Update on Resolution 20-664 – Points 1a to 1d

To address point 1 within the resolution (20-664), Creative Capital and relevant Council staff have held meetings to discuss and address the various aspects of the EOI that required further refinement.

Image below of original masterplan layout – Council lots shown in red and Creative Capital lots shown in green (refer to Attachment 4 page 61 of the document)

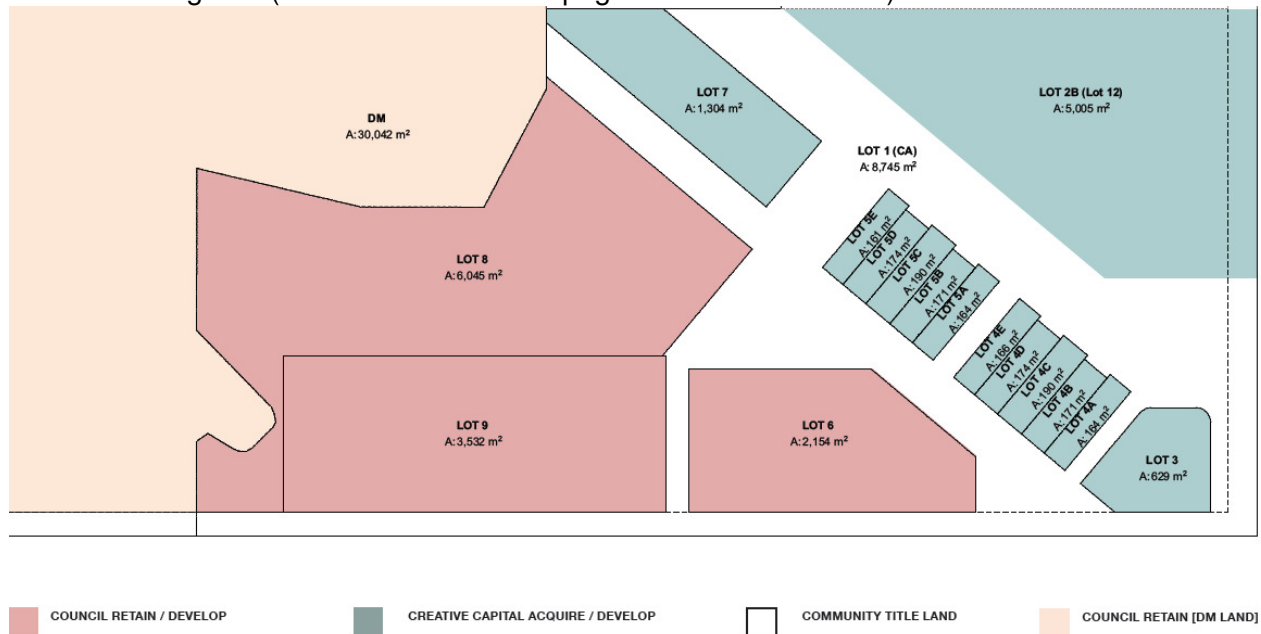
Original masterplan – Council lots

The original masterplan included 11,731m² of proposed Council land. However these lots were:

- heavily constrained by ecology and bushfire setbacks;
- irregular in size and shape; and
- located at the back of Lot 12 with limited exposure to Bayshore Drive or the main internal access road.

Image below of revised masterplan with proposed Council land outlined in red

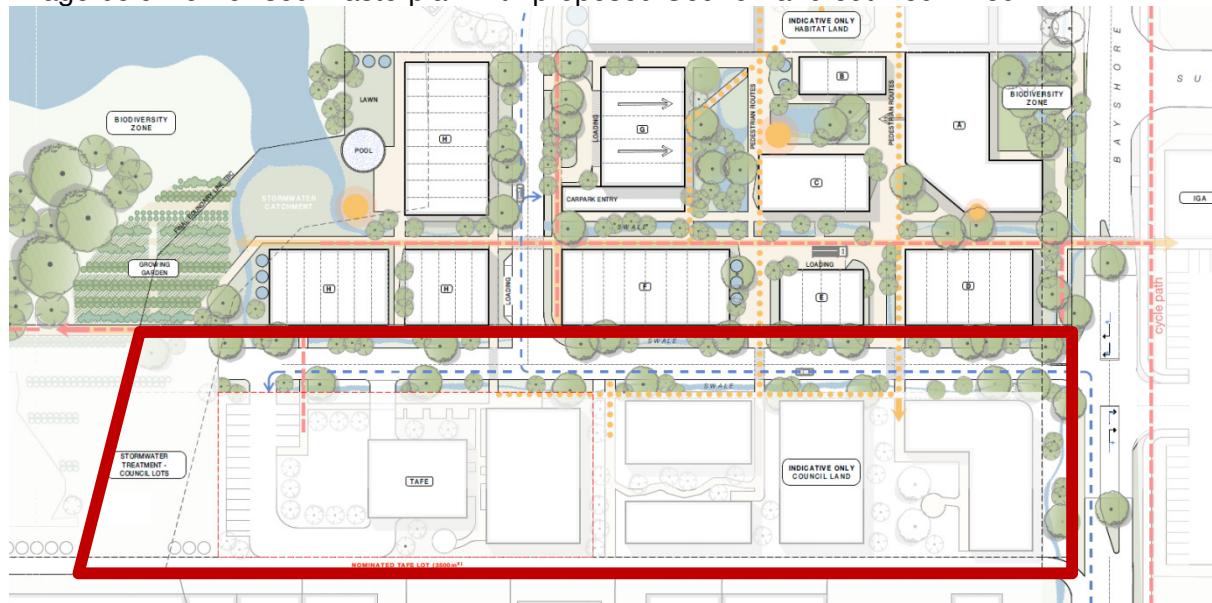
b) Structure and land uses on proposed Council lots to be defined by Council

Revised masterplan – Council lots

The revised masterplan includes 13,580m² of proposed Council land. These lots have no major constraints and have good exposure to Bayshore Drive and the main internal access road.

Proposed Council land includes approximately:

- 3,500m² for the TAFE Connected Learning Centre
- 4,503m² for future development (which can be further subdivided as needed)
- 5,577m² for infrastructure including roads, stormwater treatment etc)

Image below of revised masterplan access and movement plan (refer Attachment 1 page 19 of the document)

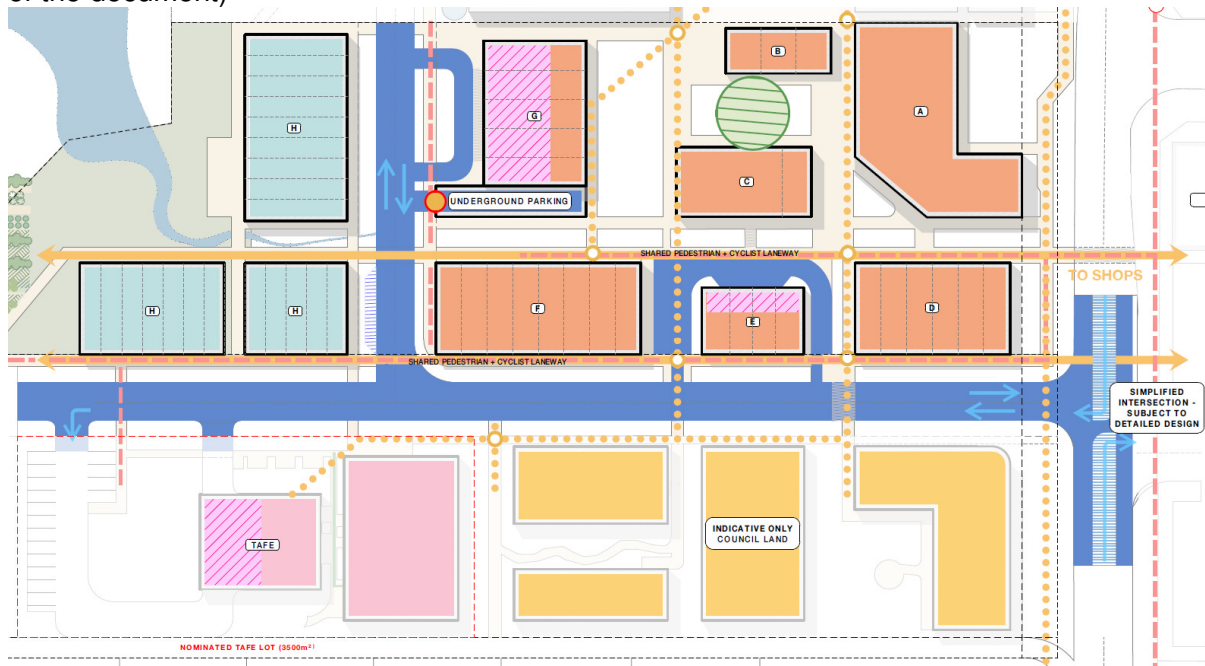
- c) Site access, frontage and entry to better prioritise pedestrian and cyclists movements, including a revision of the traffic study to consider all options, not just a roundabout**

The revised masterplan proposes a more appropriately scaled four-way intersection on Bayshore Drive that prioritises people and bikes over cars. This proposal will

need to be verified at the next stage with appropriate movement study to analyse this intersection upgrade.
